Amendments to the Drawings:

Remarks/Arguments:

FIG. 2A

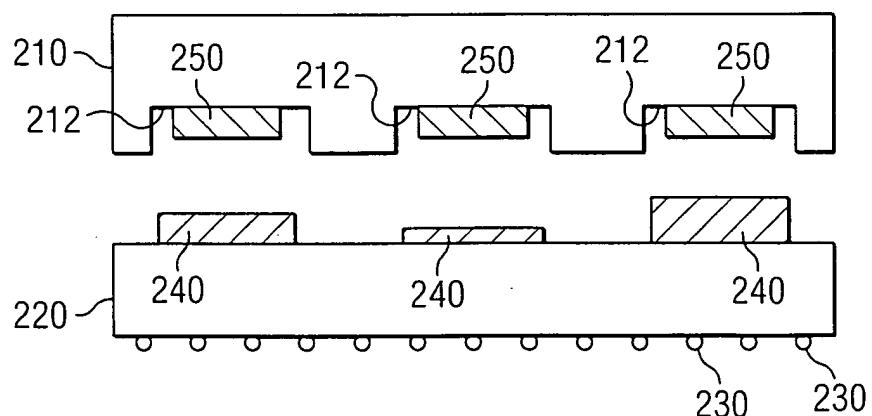
The attached sheet of drawings includes changes to Fig. 2A and the new drawing, Fig. 2B, replaces the original sheet including Fig. 1, 2, and 2A. In Figure 2A, o the missing elements 260 on top of the dies are added, and the thickness of elements 260 that contact the substrate 220 is reduced with respect to the chip thickness to depict the embodiment more closely. No new matter is added.

Fig 2B added

260
added

lowered.
